Placer County Office of Education

Office Building Tenant Improvements, Annex Building Alterations, & Site Improvements @ Various Sites

ADDENDUM NO. 2

Friday, September 1, 2023

1 FIRST FLOOR OVERALL DEMOLITION PLAN

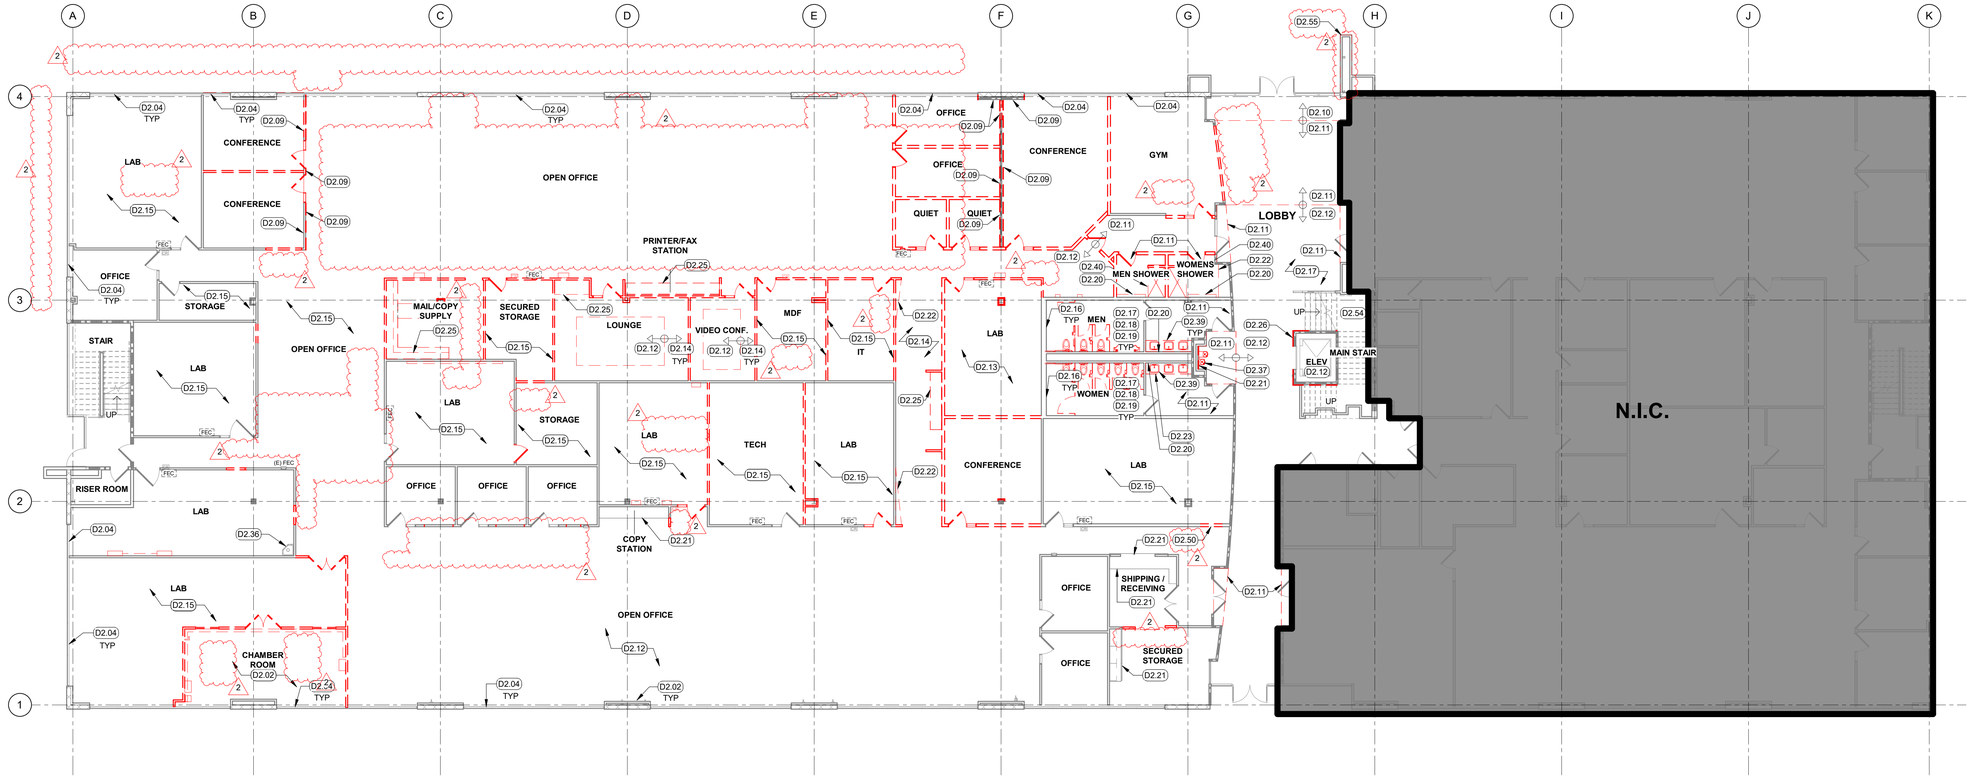
2.14 **1400 Stanford Ranch - SHEET A2.01 – Extent of Demo Work**

1 DEMO PLAN - SECOND FLOOR

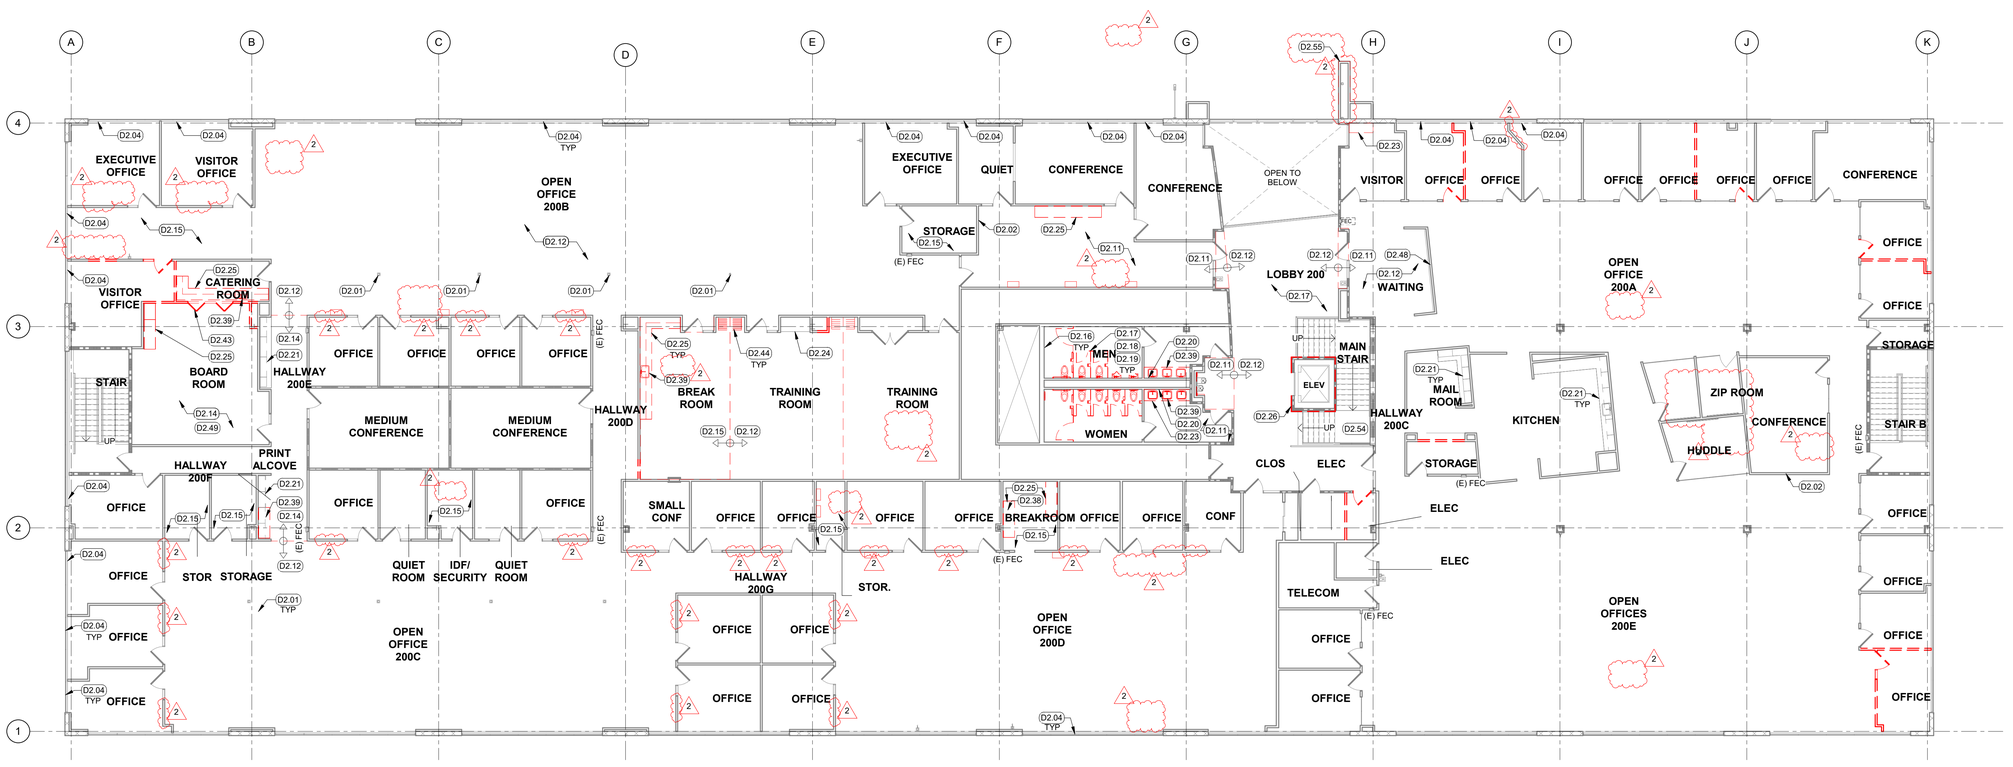
2.15 **1400 Stanford Ranch - SHEET A2.02 – Extent of Demo Work**

1 FIRST FLOOR PARTIAL REMODEL PLAN - WEST
1/8" = 1'-0"

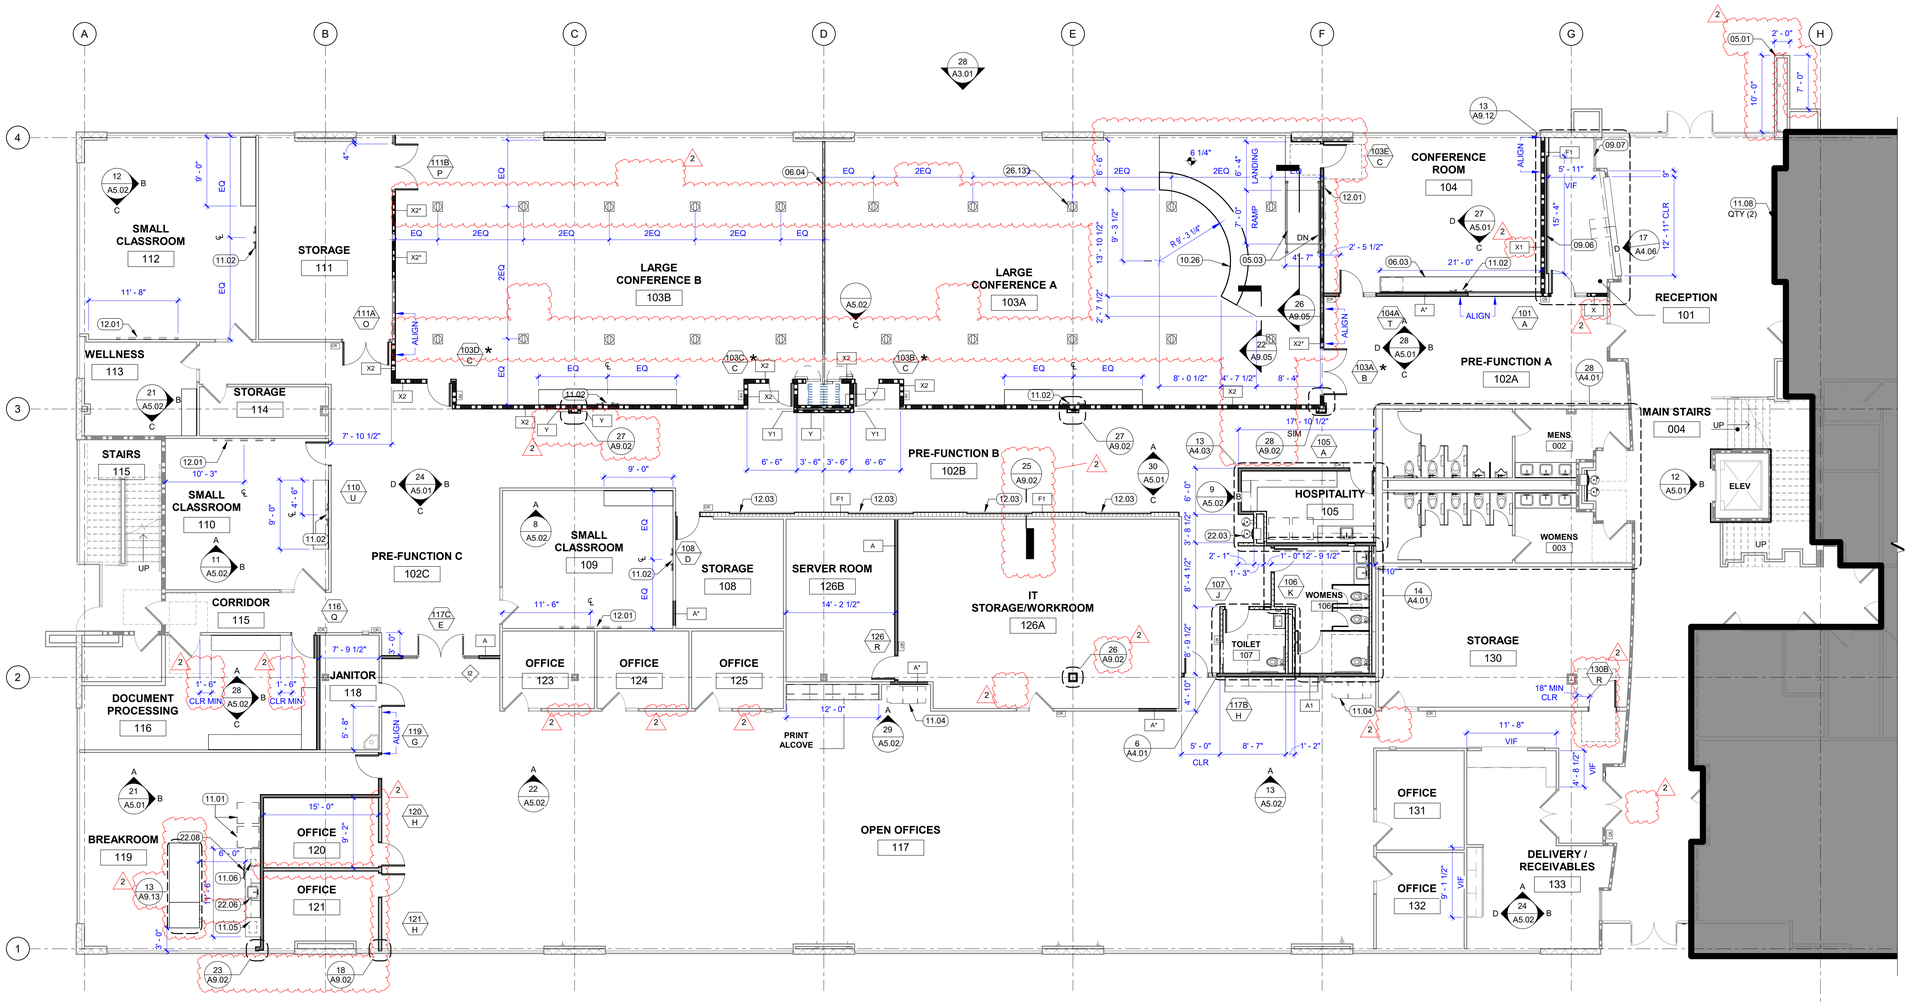
2.17 **1400 Stanford Ranch – SHEET A2.06 – Extent of New Work**

7. *New Main Office: A specification is provided for 10 22 26 Operable Wall Partitions is provided, however, no call-out is indicated on the plans. It appears that this is to be located at Gridline D on page A2.06, however, the partition is noted with a casework call-out. Please clarify and confirm which partition details are applicable from the plans.*

Response: Callout on A2.06 revised to correspond with new operable wall partitions.

1 SECOND FLOOR PARTIAL REMODEL PLAN - WEST
1/8" = 1'-0"

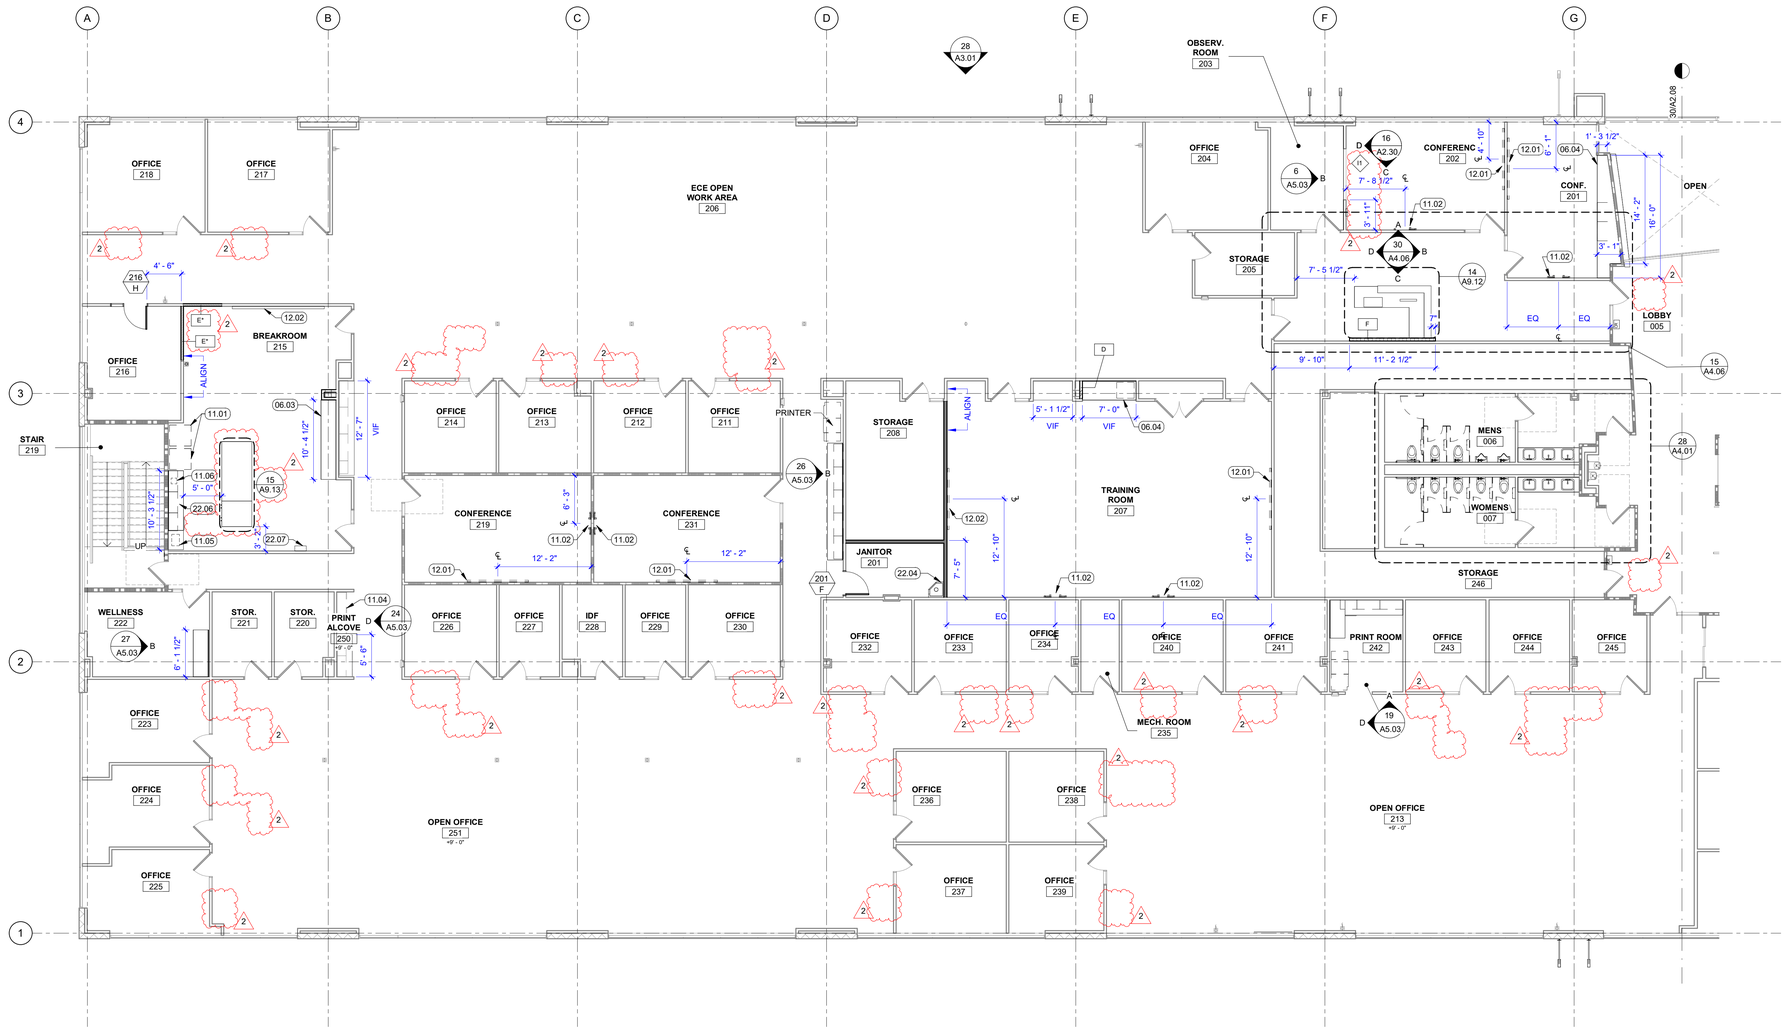
2.18 **1400 Stanford Ranch – SHEET A2.07 – Extent of New Work**

1 SECOND FLOOR PARTIAL REMODEL PLAN - EAST
1/8" = 1'-0"

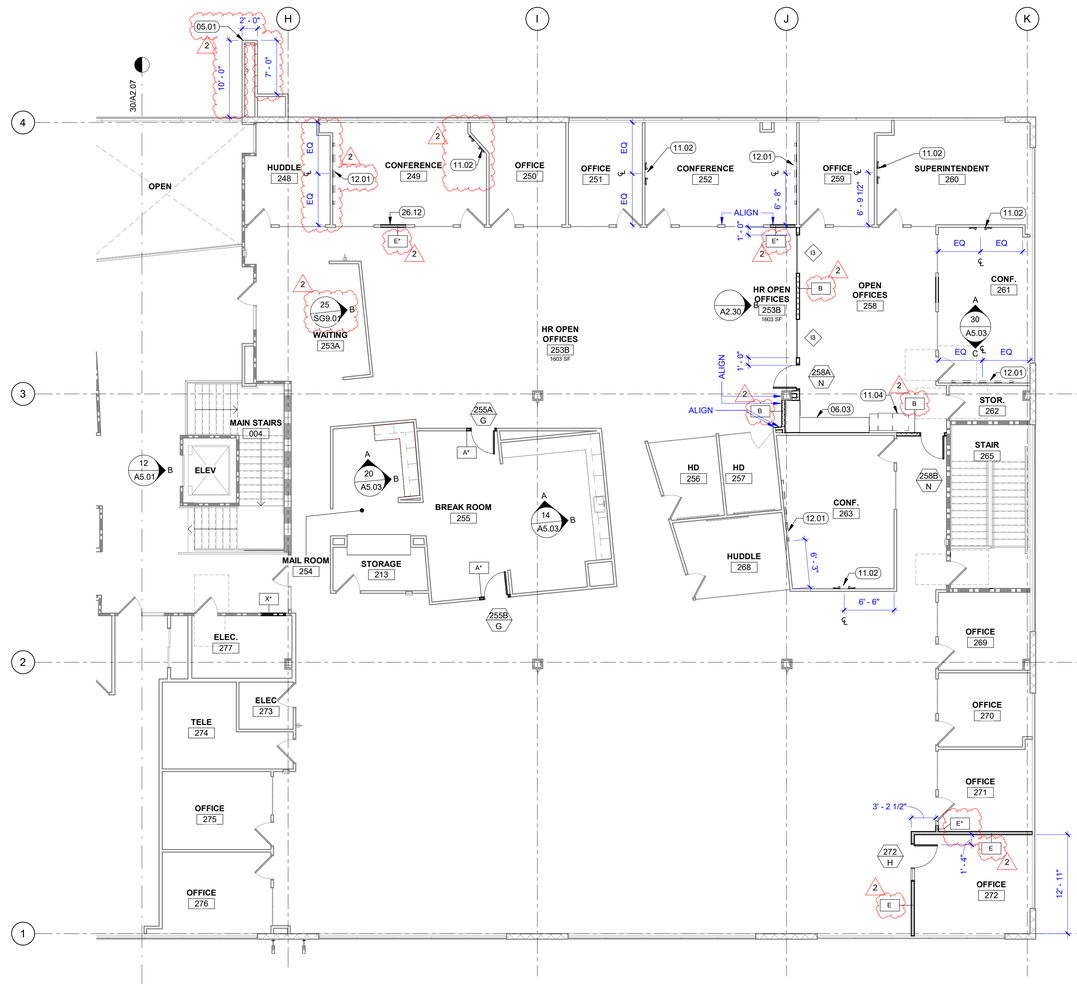
2.19 **1400 Stanford Ranch – SHEET A2.08 – Extent of New Work**

27 INTERIOR STOREFRONT AND WINDOW TYPES

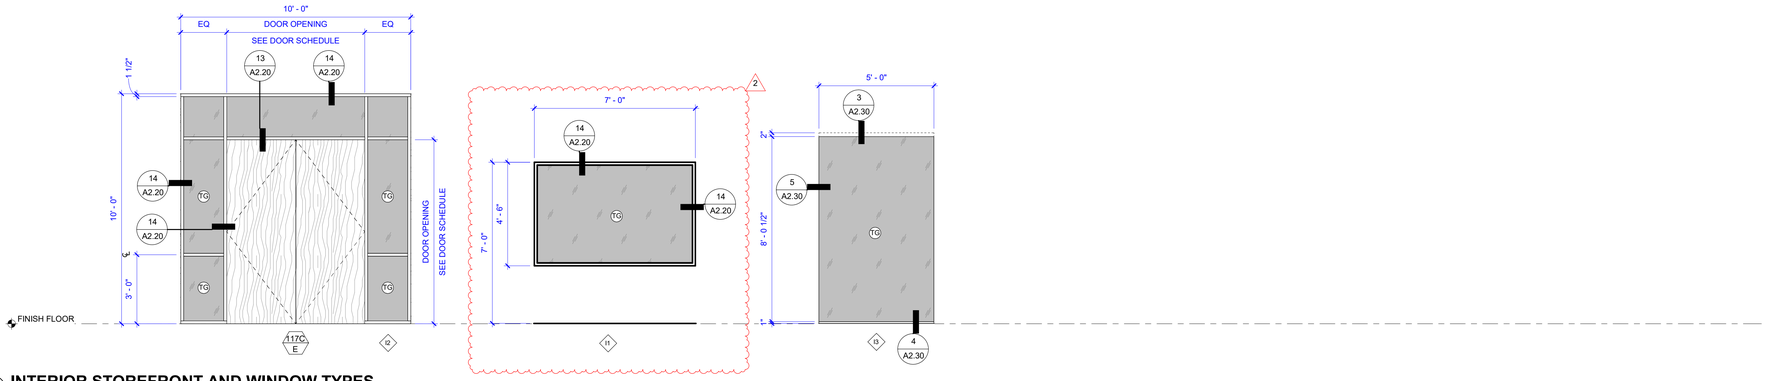
A. **OMIT** window types I4, I5, and I6 from scope. **See attached 'Sheet A2.30'.**
